**MEMORANDUM**

SUBJECT: Special Protection Area (SPA) Preliminary Water  
Quality Plan for Hunt-Miles Property (associated with Development  
Plan Amendment DPA 02-1)

Re: **Preliminary Water Quality Plan** for Hunt  
Property-Miles Tract  
Preliminary Plan #: 1-98094  
SM File #: 204466  
Tract Size/Zone: 48.2 Ac/PD-2  
Tax Plate: KR 343  
Liber/Folio: 2836/344 & 3815/138  
Montg. Co. Grid: 32B5  
Watershed: Upper Paint Branch

DEVELOPMENT PLAN AMENDMENT  
LAND USE PLAN

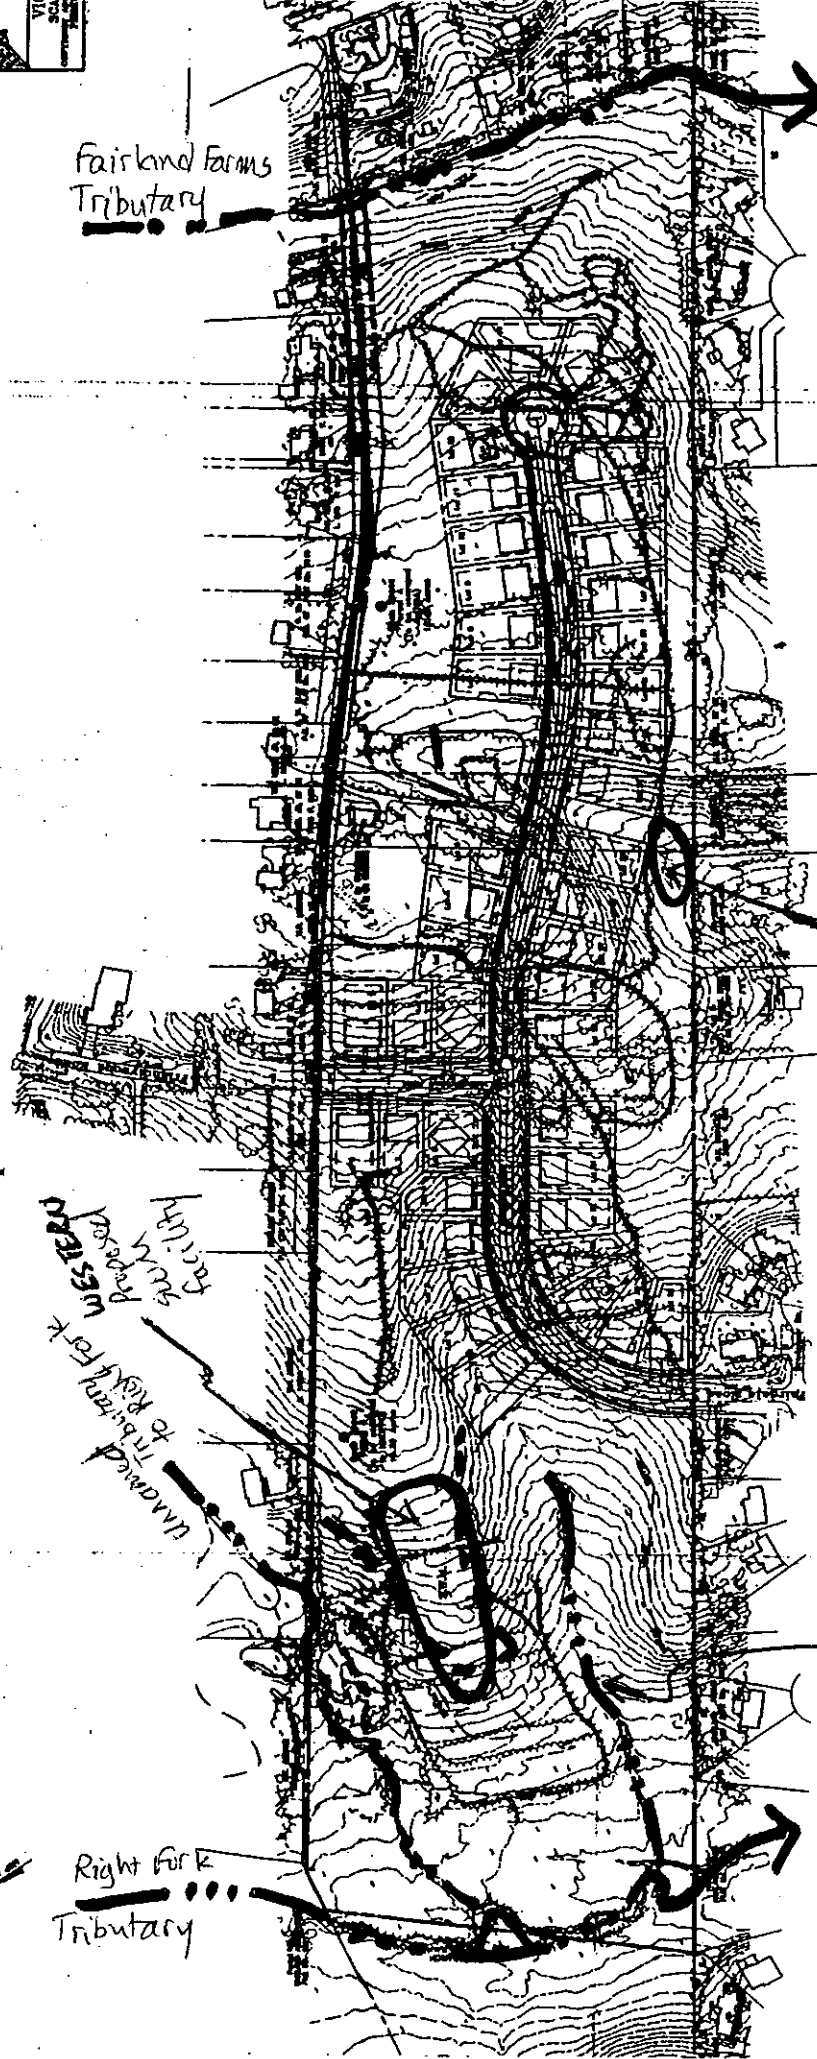
The Upper Paint Branch SPA is the only SPA that has a ten percent (10%) site imperviousness limit on new development. The imperviousness limit is set forth in the environmental overlay zone for the Upper Paint Branch SPA. The water quality plan proposes a site imperviousness of 10 percent. This consists of 44 single-family detached houses (each with an average footprint of 2222 square feet) and driveways, roads, and sidewalks (see Attachment C). The applicant's proposal conforms to the environmental overlay zone.

The applicant proposes to locate a stormwater management (SWM) facility in such a way that there would be about 11,500 square feet (0.26 acre) of grading within the western environmental buffer. Most (about 9270 s.f.) of this proposed buffer encroachment is currently not forested and the forest loss (about 2230 s.f.) within the buffer is for a necessary outfall pipe for the SWM facility.

Although the forest loss within the environmental buffer resulting from the applicant's proposed location of the SWM facility and its outfall pipe is small, staff believes that the SWM facility should be reconfigured to avoid any grading within the buffer area except for the necessary outfall pipe. If the SWM facility is not relocated, there would be a portion of the buffer (over 9000 s.f.) that could not be planted in forest since part of the facility's dam embankment would be in the buffer and Montgomery County Department of Permitting Services does not allow trees on such embankments. By relocating the facility outside the buffer, forest

could be planted or be allowed to naturally regenerate within the entirety of the buffer. The relocation would not affect the proposed layout of the subdivision nor the facility's effectiveness as a SWM control structure.

It should be noted that staff's recommendation to relocate the SWM facility completely outside the environmental buffer will result in forest clearing outside the environmental buffer of 13,780 s.f. (0.32 acre). The part of the forest that would be cleared is only along one edge of a young forest stand which is dominated by Virginia pine and black cherry. Staff believes the additional forest clearing outside the buffer is an acceptable loss, given that there is a long-term gain of creating forest cover for the entirety of the environmental buffer.
